Letter I51j

Subject: Revised DEIR Public Comments Regarding Water, Noise Impacts, and DEIR Chapter 2 Noise Impacts, Lilac Hills Ranch General Plan Amendment and Specific Plan PDS2012-3800-12-001(GPA), PDS2012-3810-12-001 (SP).

Subject: DEIR Public Comment to the Proposed Accretive Lilac Hills Ranch General Plan Amendment and Specific Plan PDS2012-3800-12-001(GPA), PDS2012-3810-12-001 (SP), DEIR Chapter 2.8 Noise; Noise Report of the proposed Lilac Hills Ranch (LHR) Project

On-site 60 CNEL Noise Level Contours (South)

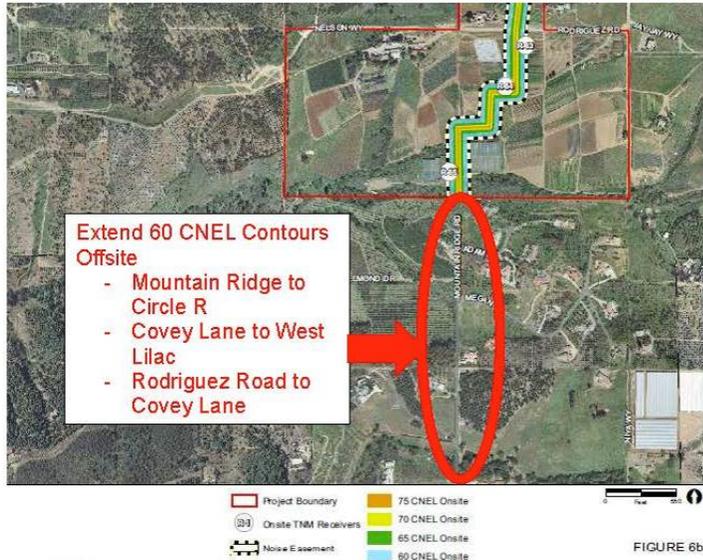
The 60 CNEL Noise Level Contour Graphic needs to be extended to include the Off-Site Impacts for ALL of the Projects Secondary Access Roads:

- Mountain Ridge from the Subdivision boundary to Circle R Drive
- Covey Lane from the Subdivision eastern boundary to West Lilac Road
- Rodriguez Road to Covey Lane

This Graphic will highlight several areas of inconsistencies in the DEIR Subchapter 2.8 – Noise and the Noise Report.

For example, DEIR Subchapter 2.8 – Noise **2.8.2.1 Issue 1: Traffic Generated Noise** p.28 -8:

"Existing receivers along Mountain Ridge Road south of the project site would experience a potentially substantial increase in ambient noise levels of 8 CNEL, however, noise levels within 100 feet of the roadway centerline would be 53 CNEL or less."

When Mountain Ridge Private Road traffic volume is increased to the levels indicated in

the August 16, 2013 Darnell Associates Independent Expert Review, and the 60 CNEL Noise Level Contour line is plotted on Mountain Ridge, in excess of 60 CNEL will be indicated at the residential façade at 31013 Mountain Ridge (APN 129-430-13-00).

This Graphic will highlight other Off-Site Impacts where Cumulative Noise Levels exceed County Standards on Covey Lane and Rodriguez Road.

151j-13 The comment states that the On-Site Noise Level Contour Graphic, Figure 6b of the Noise Technical Report and Figure 2.8-2b of the FEIR, needs to be extended to include off-site impacts for all of the project's secondary access roads. This Figure 6b was revised to include the continuation of the future build-out noise contours at off-site residences prior to the 2014 public review period. The 60 dB noise contour is now shown for Mountain Ridge Road and Covey Lane as requested. In addition, the project off-site noise impacts to existing residences are assessed in Tables 11, 12, and 13 showing direct and cumulative noise impacts, Figures 7a and 7b showing potential off-site noise impacted locations, and evaluation is provided in Section 2.3.
